Docket Number:	81-AFC-01C
Project Title:	Compliance - Application for Certification of the Occidental Plant # 1
TN #:	227761
Document Title:	Response to Staff's Informal Data Request and Technical Appendix
Description:	N/A
Filer:	Deric Wittenborn
Organization:	Ellison Schneider Harris & Donlan LLP
Submitter Role:	Applicant
Submission Date:	4/18/2019 4:08:48 PM
Docketed Date:	4/18/2019

RE: Calistoga Geothermal Project (Unit 19) (81-AFC-01C): Petition for Modification: Responses to Staff's Informal Data Request and Technical Appendix

Calistoga Geothermal Power Plant, “Unit 19” (81-AFC-01C)
Petition for Modification to Replace 21 kV Standby Circuit

New scope of work

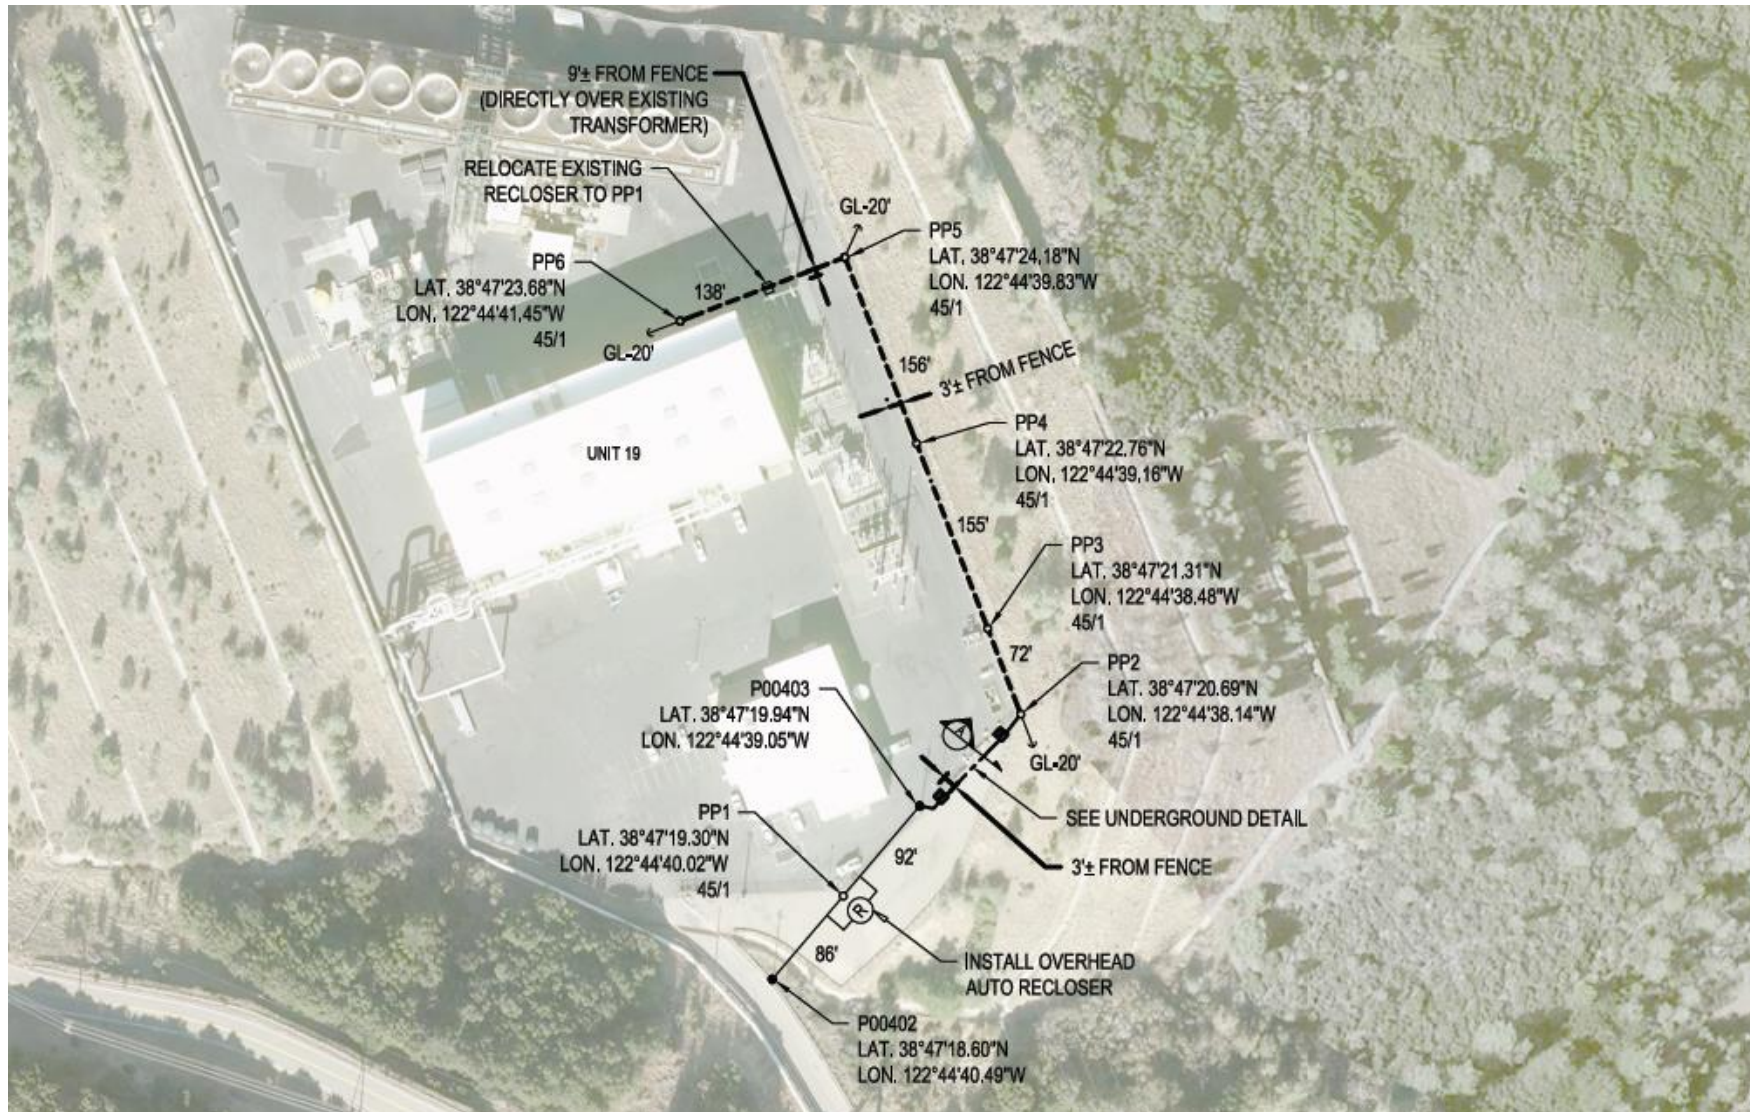
- 4. Staff Informal Data Request #4: Please confirm that there is only one new pole proposed.*

Six new poles are proposed, as shown in Attachment 1, Figure “New Scope of Work”. New poles as “PP”—for example, “PP1” refers “Power Pole 1”.

CALPINE GEYSERS		JOB NUMBER	REV
UNDERGROUND TO OVERHEAD CONVERSION		153941	0
PLAN VIEW		DRAWING NUMBER	P2-1

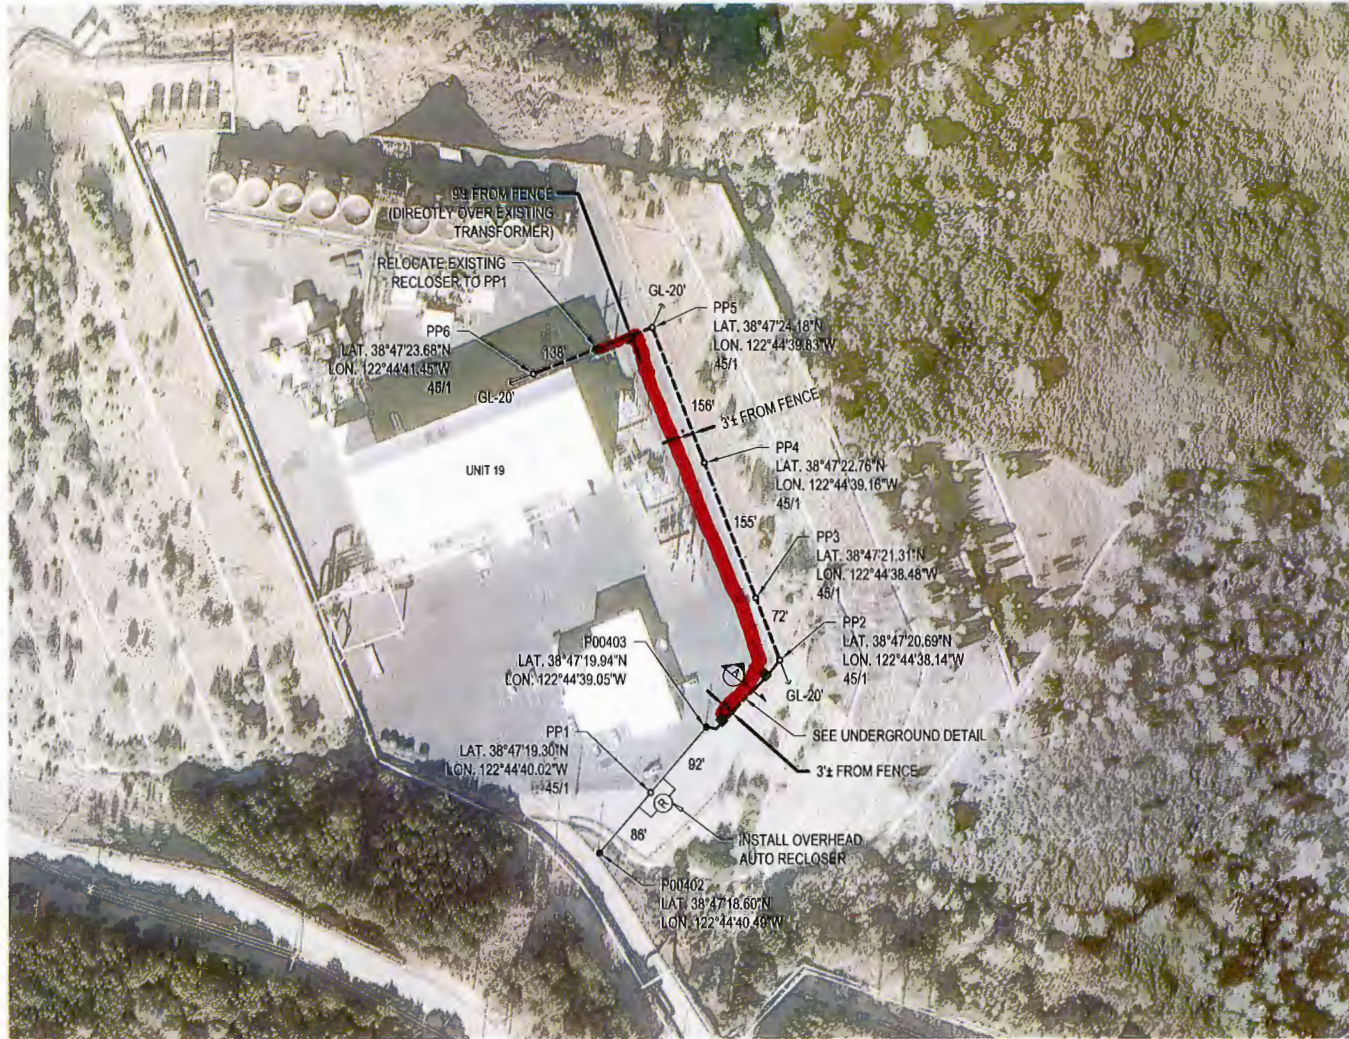
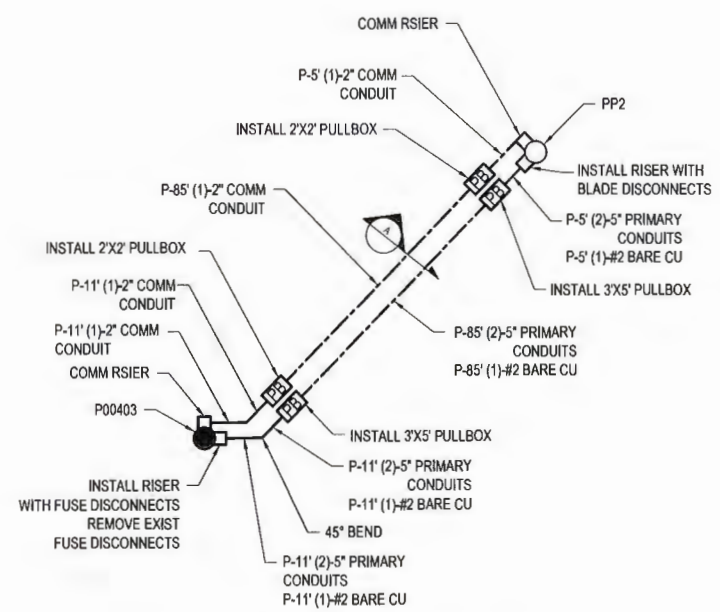
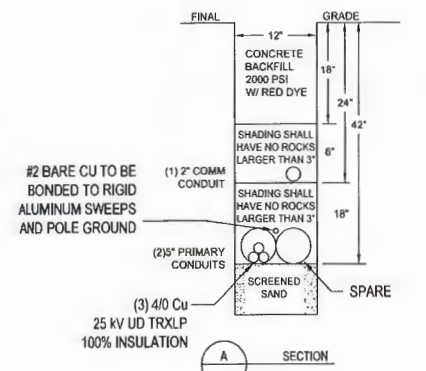
- 3. Staff Informal Data Request #3: Please indicated the distance of the run of all portions of this project, both underground and aboveground line. Please include more detail about the various portions of work, any excavation, crane work, work necessary to “tie off” the line to be abandoned, etc.*

The excavation for the poles will include augured holes for poles and guy anchors. The excavation for the new underground conduit/cable will be approximately 12 inches wide and 42 inches deep, for approximately 100 feet. The poles will be set with a crane. Existing u/g conductors will be pulled if feasible. If not feasible, the conductors will be abandoned in place (cut) with conduits grouted/sealed (i.e. no excavation for existing circuit).
